## SERVICE BULLETIN

<b>Notification Number</b>	<b>SB-10-07-20</b>
<b>Subject</b>	<b>TCM Special Service Instruction SSI10-5</b>
<b>Supersedes Notices</b>	<b>None</b>
<b>Release Date</b>	<b>July 20, 2010</b>
<b>Effective Date</b>	<b>July 20, 2010</b>
<b>Required Corrective Action</b>	<b>Immediate compliance with TCM Special Service Instruction</b>
<b>Affected Make</b>	<b>American Legend Aircraft</b>
<b>Affected Models</b>	<b>AL3, AL11</b>
<b>Affected Serial Numbers</b>	<b>AL-1051, AL-1147, AL-1150, AL-1151, AL-1153 through AL-1157</b>

**SSI10-5**

**SUBJECT:** Part 1; Sump inspection and Oil Gage Rod replacement O200D1B S/N as listed.  
Part 2; Inspection for machining material, all O200D1B and D2B

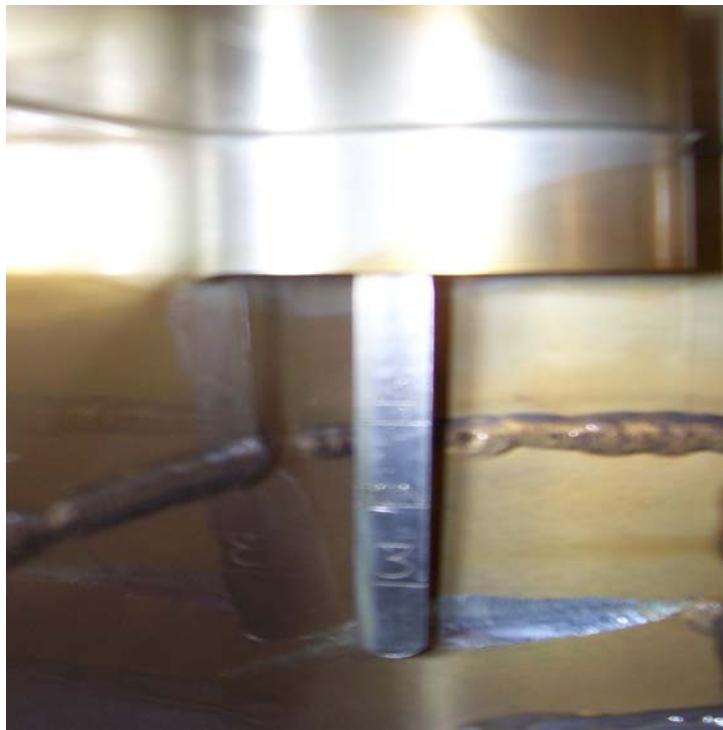
Inspected engines may continue in use, pending a replacement of the oil gage rod. The original oil gage rod, part number 657474-1, is to be temporarily replaced with a modified oil gage rod part number 657474-1-M. This oil gage rod (plug) is shortened and cannot contact the oil sump.

**The original oil gage rod must be removed and kept stored in the aircraft in a suitable protective container to allow access for use during preflight or post flight inspections and oil level servicing until a replacement oil gage rod is installed.**

After each preflight, post flight or oil level check, the original oil gage rod is to be removed from the engine and returned to its suitable protective container in the aircraft prior to starting the engine. The modified oil gage rod (plug) must be installed for all ground and flight operation of the engine.

**DO NOT OPERATE THE ENGINE OR AIRCRAFT WITH THE ORIGINAL 657474-1 OIL GAGE ROD INSTALLED IN THE OIL SUMP OF THE ENGINE. ENGINE IS TO BE OPERATED ONLY WITH THE MODIFIED OIL GAGE ROD (PLUG) 657474-1-M INSTALLED UNTIL SUCH TIME THAT A NEW REPLACEMENT OIL GAGE ROD IS OBTAINED FROM CESSNA AND INSTALLED IN THE ENGINE**
